City of Amarillo Landfill
Potter County, Texas
TCEQ Permit No. MSW-73A

Permit Modification

Compliance with New SubChapter J Requirements

Re: City of Amarillo Landfill – Potter County
Municipal Solid Waste (MSW) - Permit No. 73A
Permit Modification – Compliance with New Subchapter J Requirements
Response to Comments Dated April 28, 2009
Tracking No. 12644612; RN100237551 / CN600130942

SHEET Plate 1
App. 5B

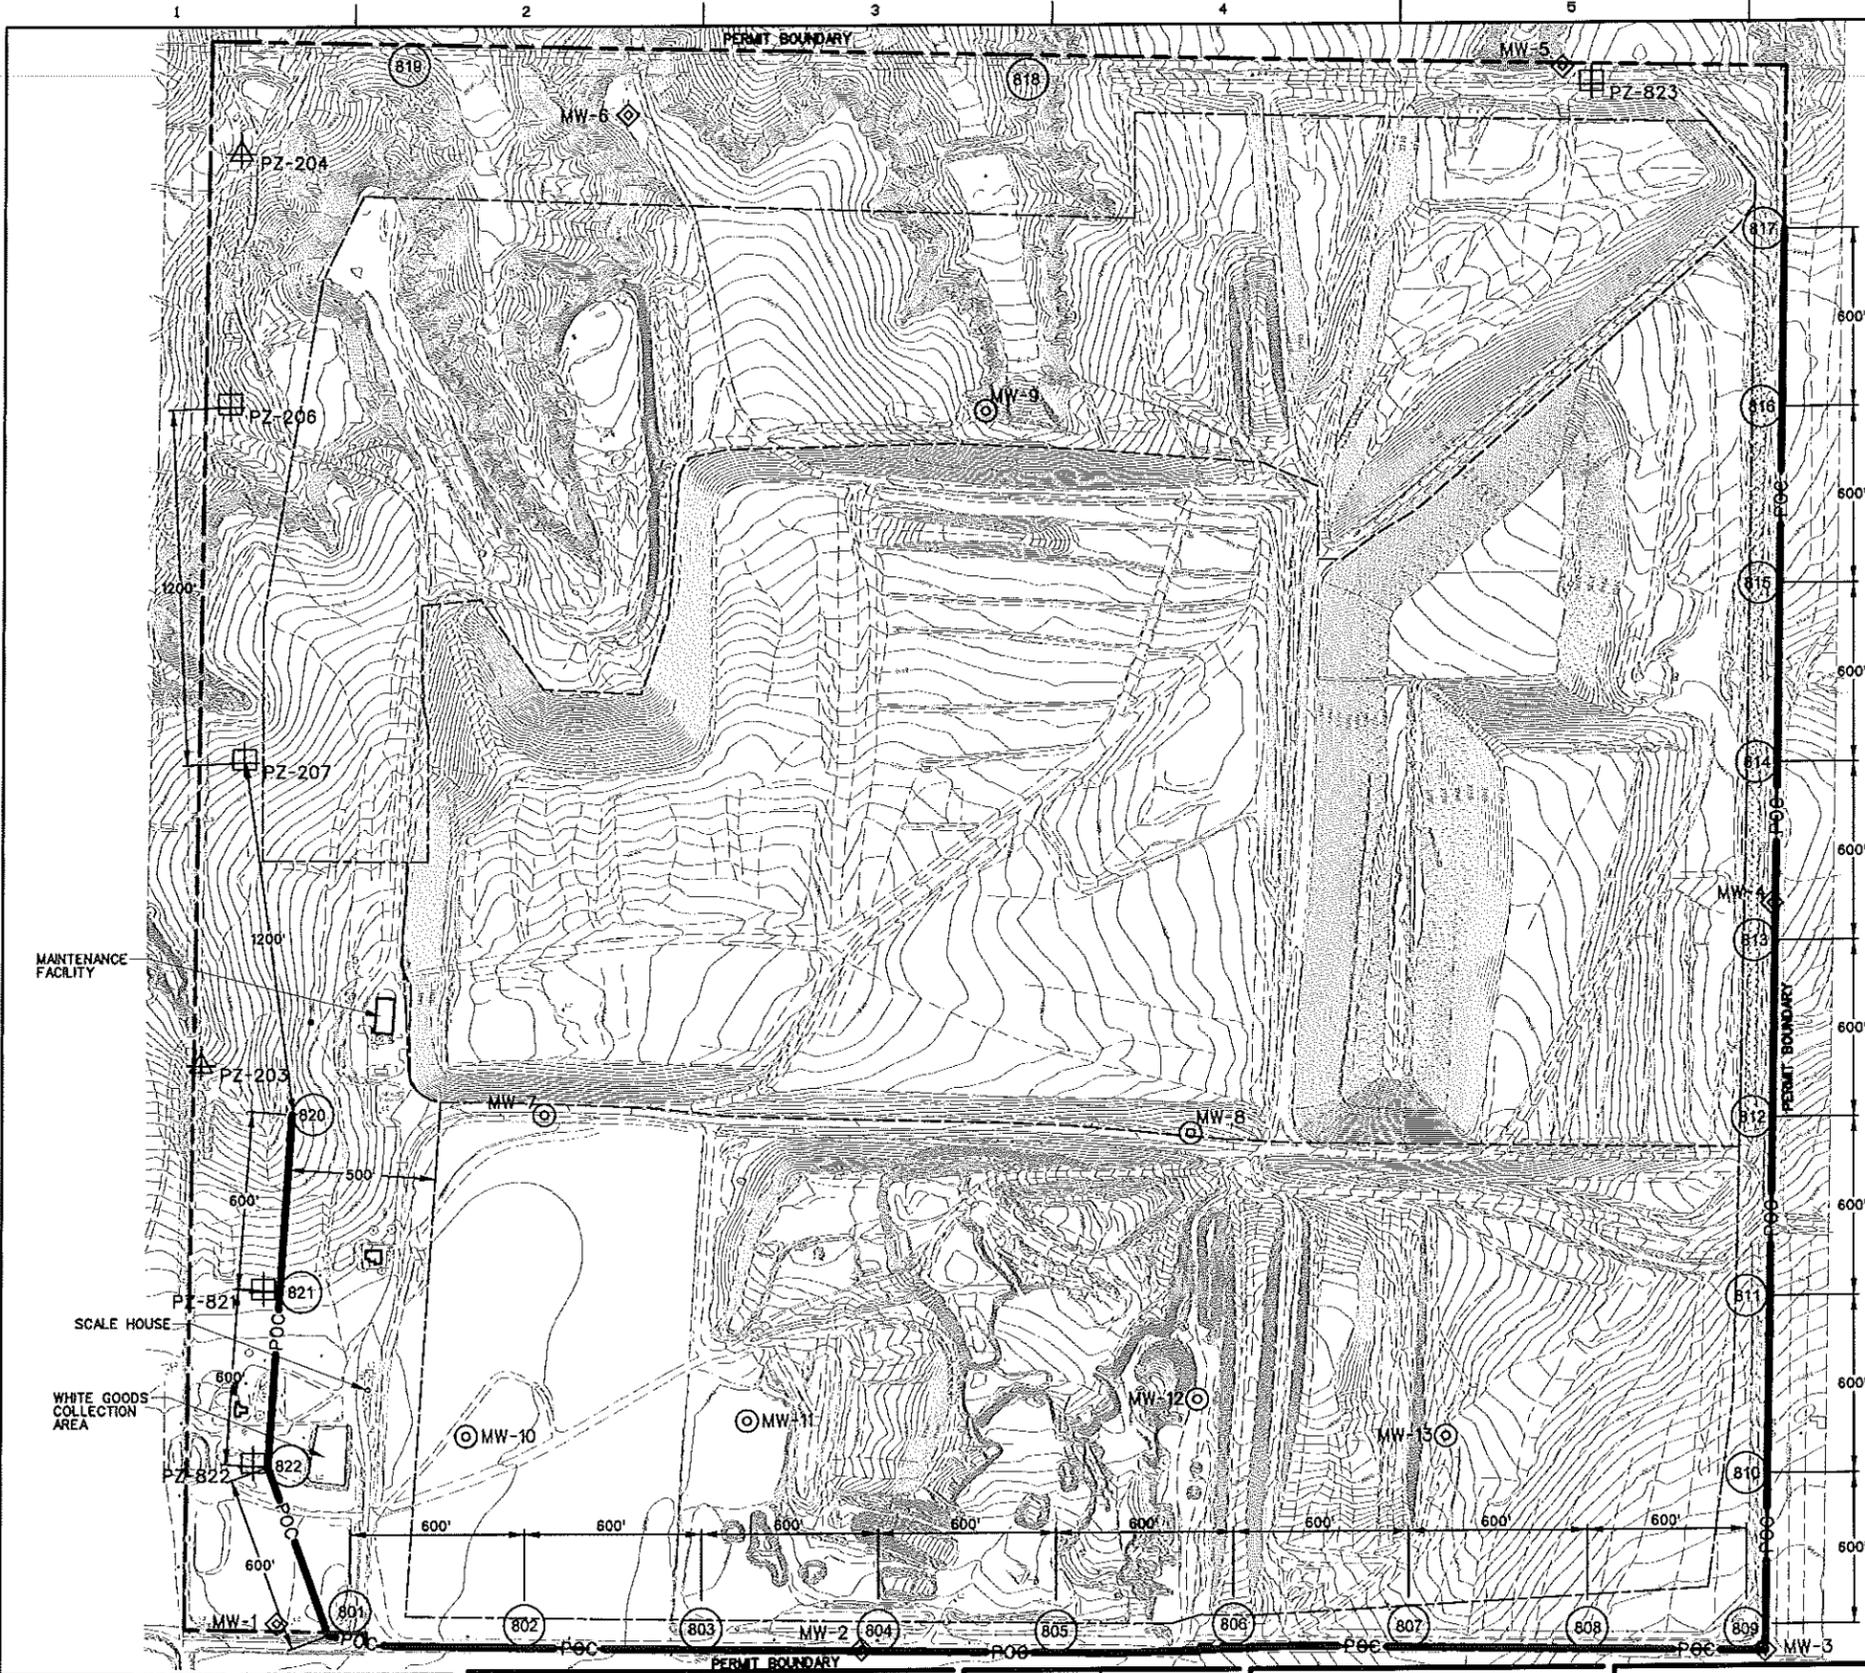
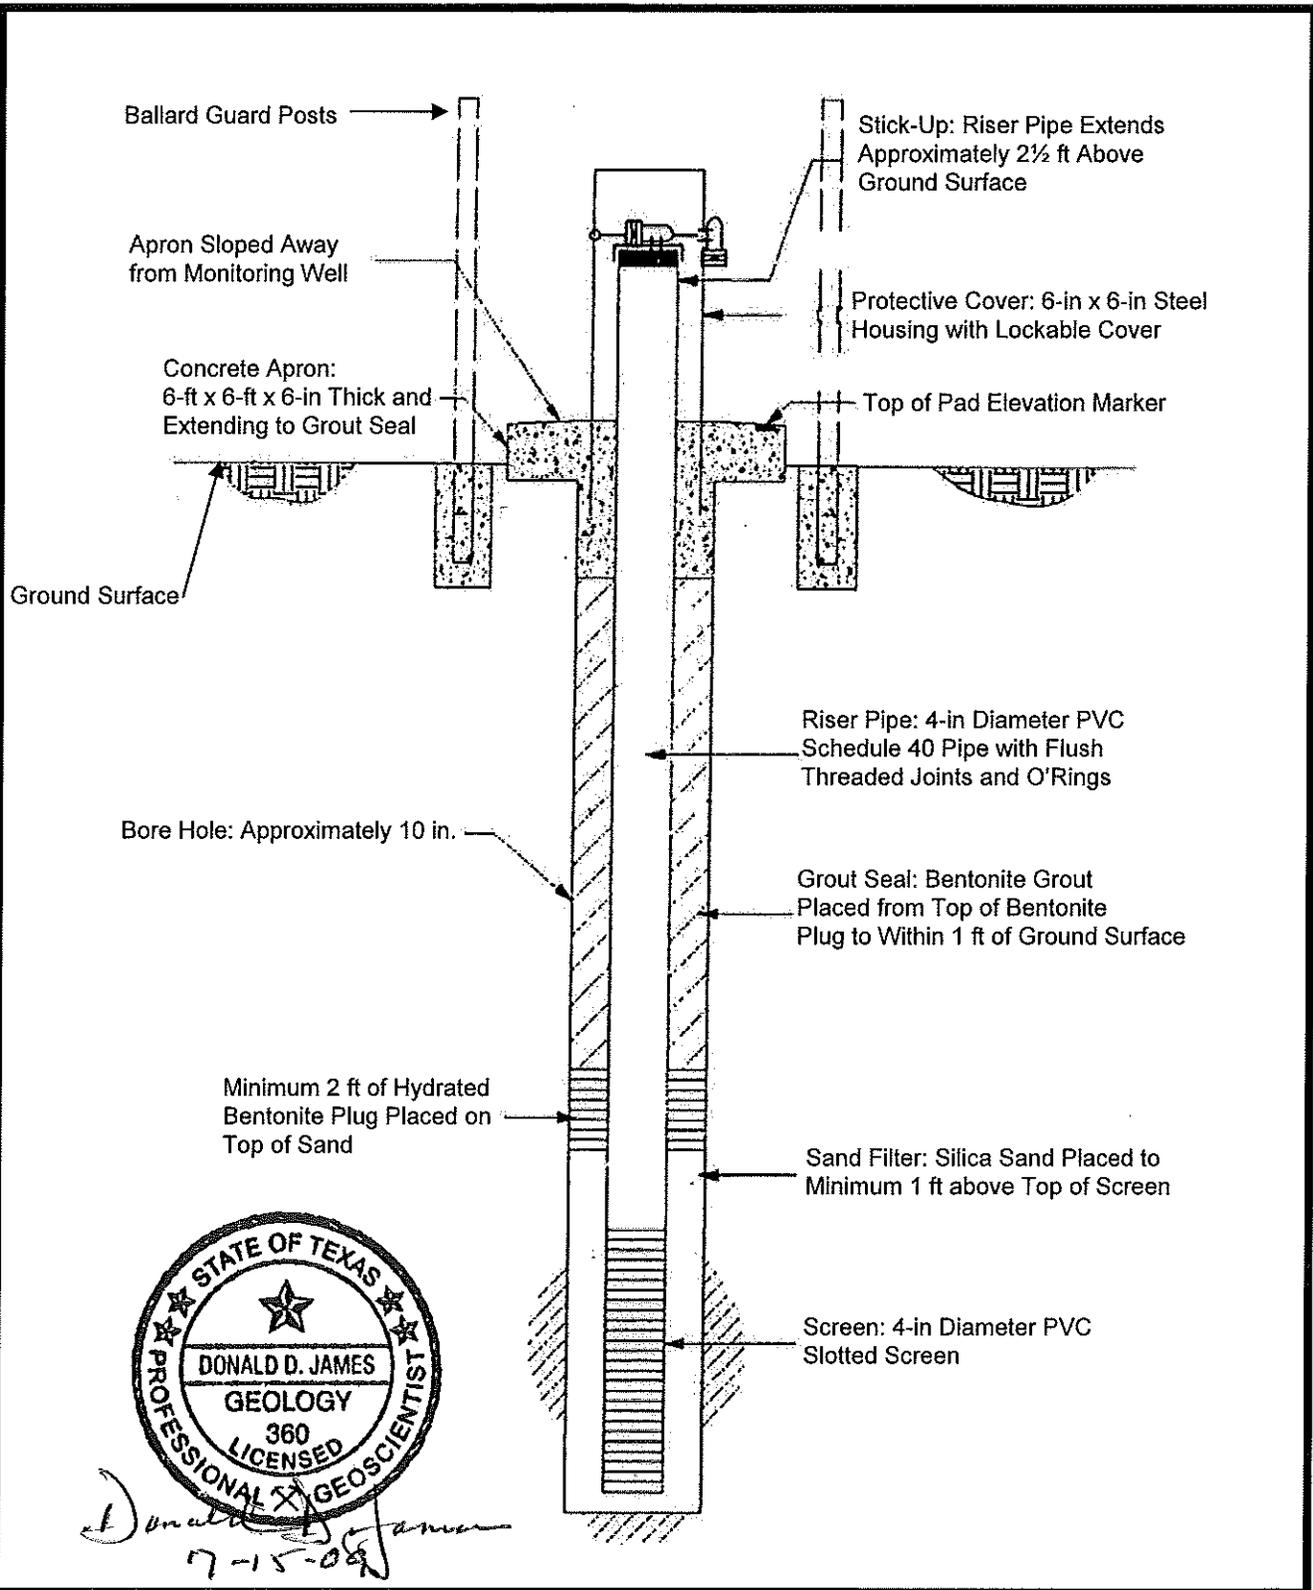
4. In Comment 4 of our February 26, 2009 NOD letter, we had asked you to provide a detailed explanation for installing at least four (4) monitor wells upgradient of the site, as opposed to installing 2 to 3 of these wells along the western boundary of the facility where little historical groundwater data has been obtained to postulate a long-term groundwater flow direction in this area. Your response states that "...ongoing water level data will better define and update the flow gradients to determine the need for additional monitoring devices along the western boundary." It goes on to say that "(d)ue to the continued decrease in groundwater elevation within the Ogallala, this ongoing evaluation will be useful since it appears that the western portion of the site may be experiencing a slight shift in groundwater flow direction (more southerly without the easterly component). Until this groundwater trend is more accurately measured with additional data from the new monitoring well network presented on Plate 1, Appendix 5B is proposed."

In considering your proposed groundwater monitoring system, we have carefully analyzed the groundwater potentiometric surface contour maps (Plates 6B.1 through 6.15) included with your application. The main problem seen in your proposed system is that its design is based on an inadequate amount of data to confidently limit the facility's point of compliance to only the southern and eastern boundaries of the site, with no compliance monitoring along the western boundary. Until the March 18, 2008 sampling event, no groundwater level data was available west of monitor wells MW-1, MW-7, MW-9, and MW-6 to better define the direction and historical fluctuation of groundwater movement in the area. Your response indicates a similar opinion, as quoted in the first paragraphs of this comment. Looking at the above plates, groundwater flow in the western half of the facility is depicted to move in a southerly to south-southwesterly direction from November 1994 through the October 2007 sampling event, using the limited data available at the time. Since the stated plates contain a large majority of information pointing toward the need for groundwater monitoring along the western boundary of the permitted waste footprint, please revise your proposed monitoring system to incorporate monitor wells along this side of the facility. By moving the proposed locations of monitor wells 814, 815, 816, 817, and 818, you can position one of these five wells as a background monitor well, leaving the remainder plus an additional few wells to extend the facility's designated point of compliance to the upper northwest corner of the site. Groundwater data obtained over time in the western portion of the site could then potentially be used in the future to provide hard evidence for revising the design of the facility groundwater monitoring system should you desire to do so.

Response: *Please see revised Part III, Attachment 5 and Part III, Attachment 5 Appendix 5B.*
